**RE: 13500 Trail Vista Court NE**  
**Grading and Drainage Plan**  
**Engineer's Stamp Date: 07/08/21**  
**Hydrology File: F23D010D**

Based upon the information provided in your submittal received 07/12/2021, the Grading and Drainage Plan is approved for Building Permit and Grading Permit. Since this project appears to have stem walls, a pad certification is not needed for this project.

# GRADING AND DRAINAGE PLAN

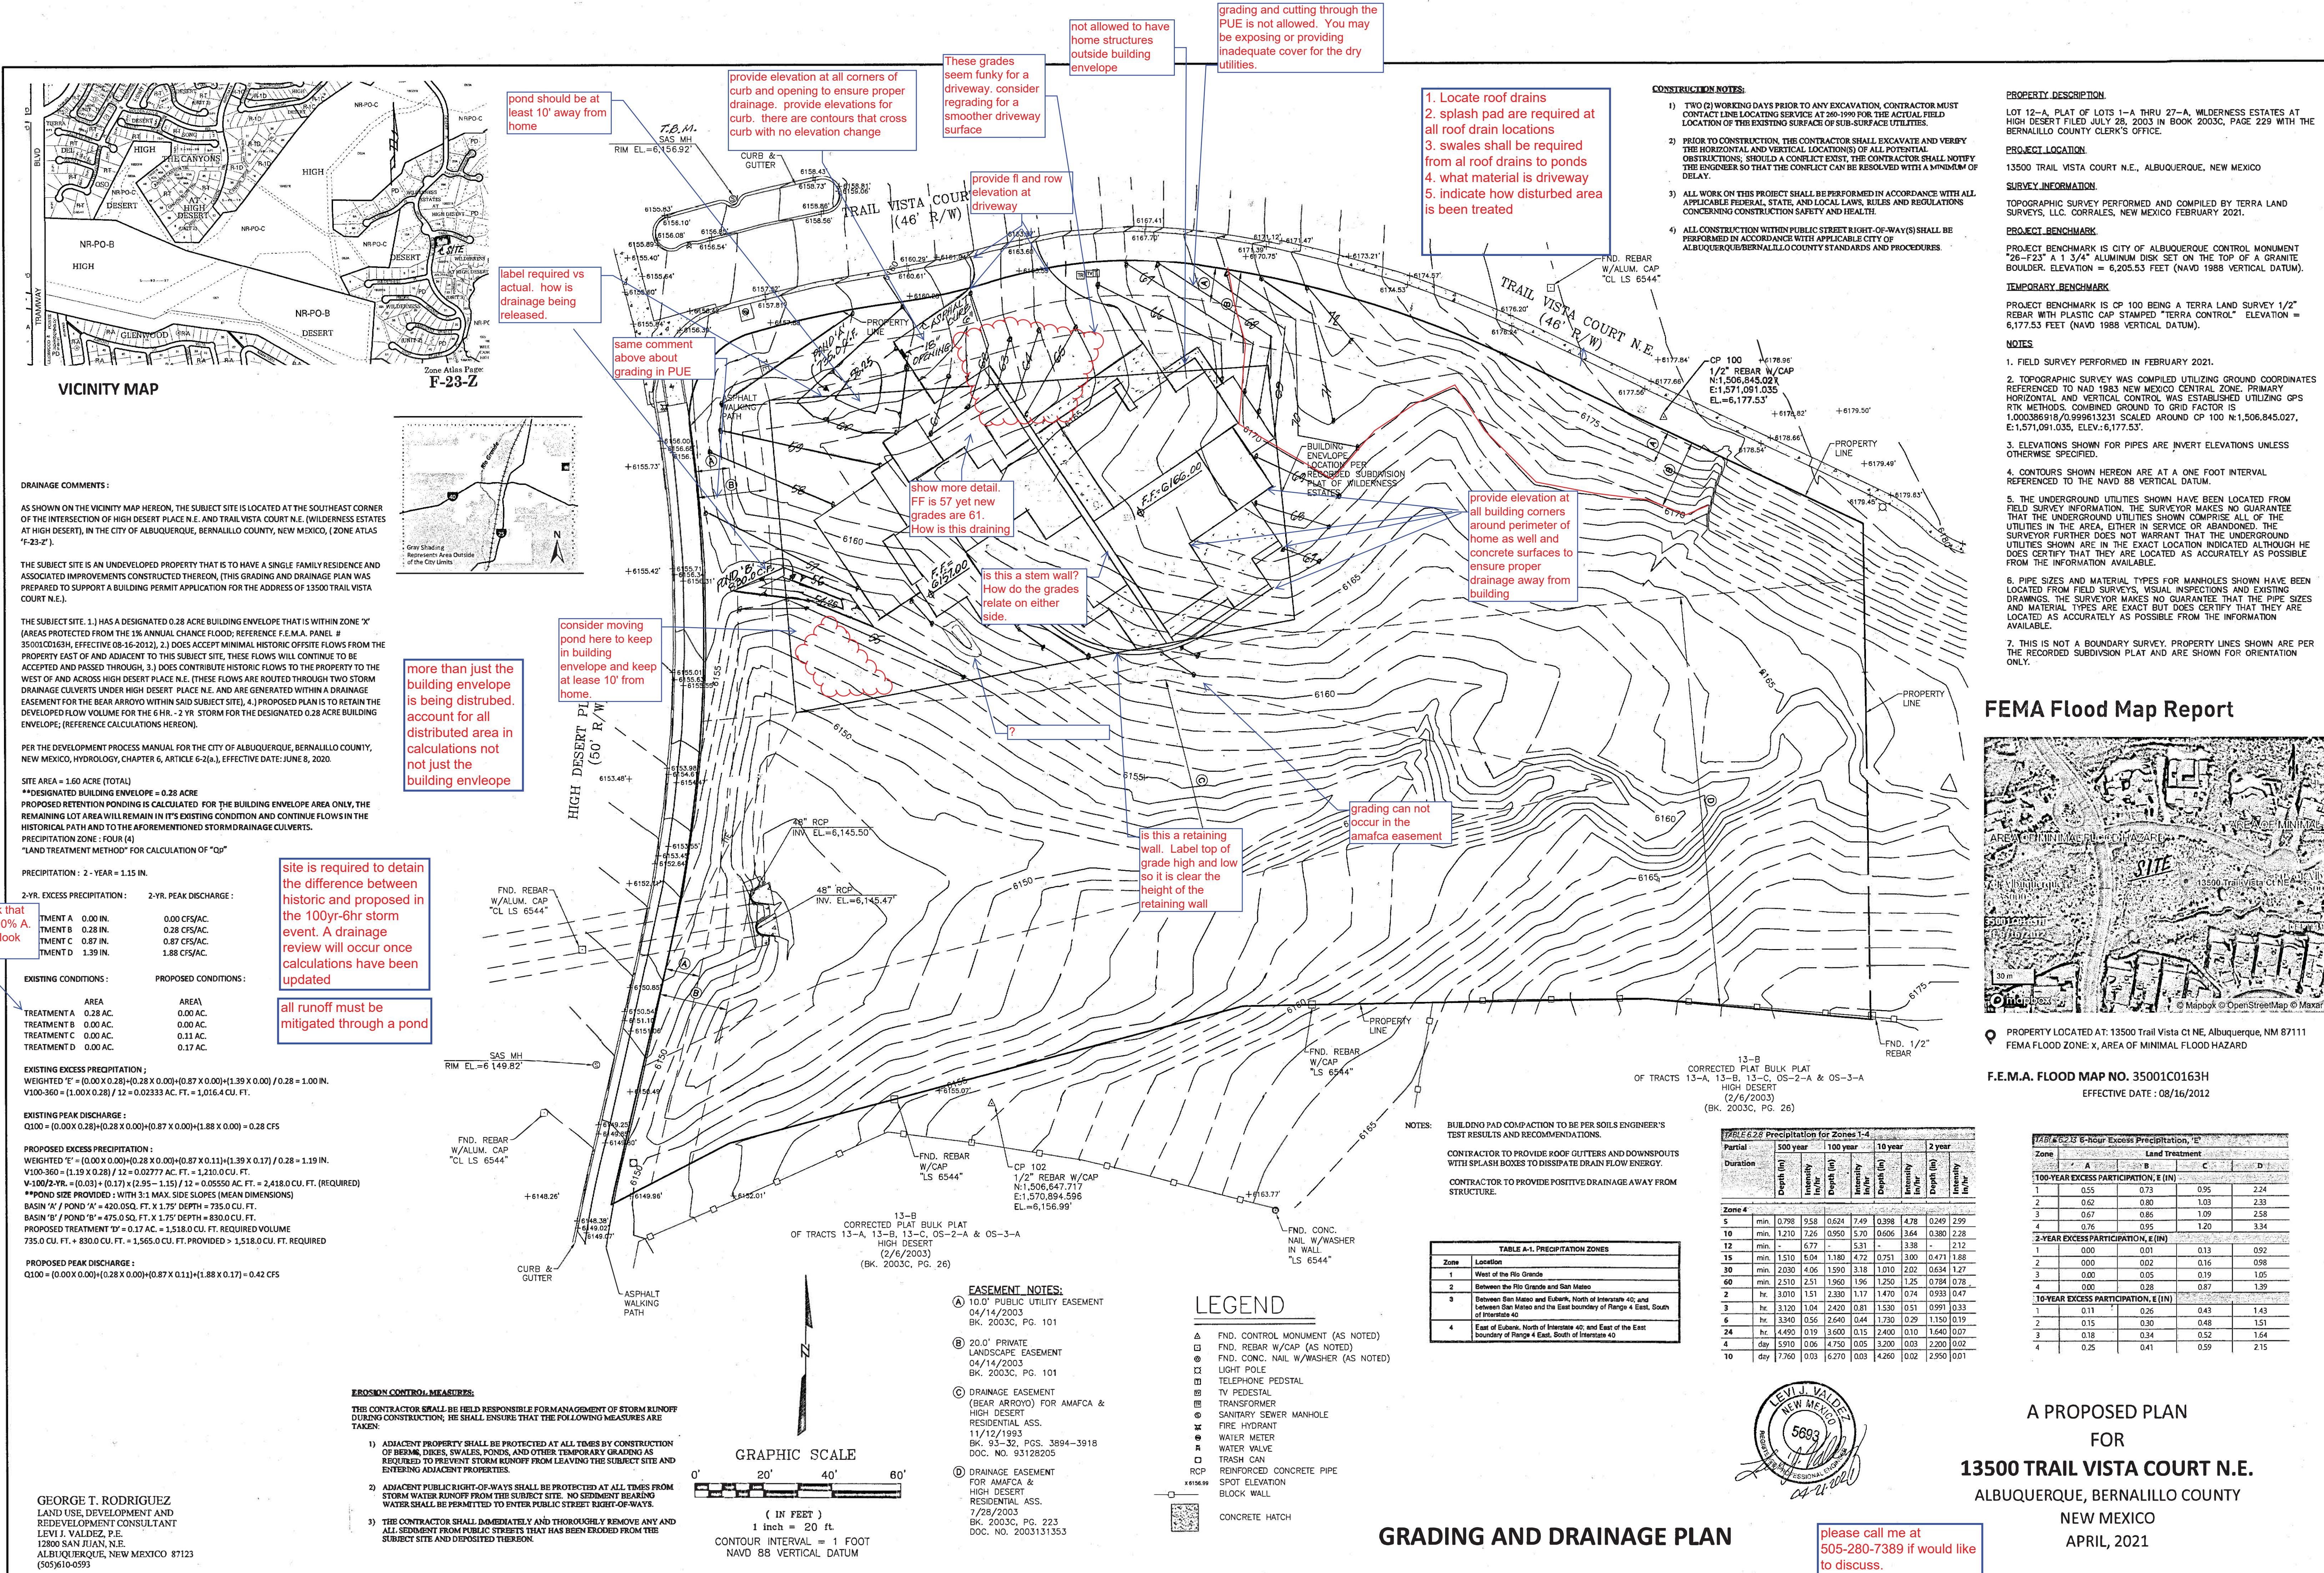
pond should be at least 10' away from home

provide elevation at all corners of curb and opening to ensure proper drainage. provide elevations for curb. there are contours that cross curb with no elevation change

These grades seem funky for a driveway. consider regrading for a smoother driveway surface

not allowed to have home structures outside building envelope

grading and cutting through the PUE is not allowed. You may be exposing or providing inadequate cover for the dry utilities.

1. Locate roof drains  
2. splash pad are required at all roof drain locations  
3. swales shall be required from all roof drains to ponds  
4. what material is driveway  
5. indicate how disturbed area is been treated

label required vs actual. how is drainage being released.

same comment above about grading in PUE

show more detail. FF is 57 yet new grades are 61. How is this draining

provide elevation at all building corners around perimeter of home as well and concrete surfaces to ensure proper drainage away from building

is this a stem wall? How do the grades relate on either side.

grading can not occur in the amafca easement

is this a retaining wall. Label top of grade high and low so it is clear the height of the retaining wall

consider moving pond here to keep in building envelope and keep at least 10' from home.

more than just the building envelope is being disturbed. account for all distributed area in calculations not just the building envelope

site is required to detain the difference between historic and proposed in the 100yr-6hr storm event. A drainage review will occur once calculations have been updated

all runoff must be mitigated through a pond

double check that existing is 100% A. Some areas look steeper
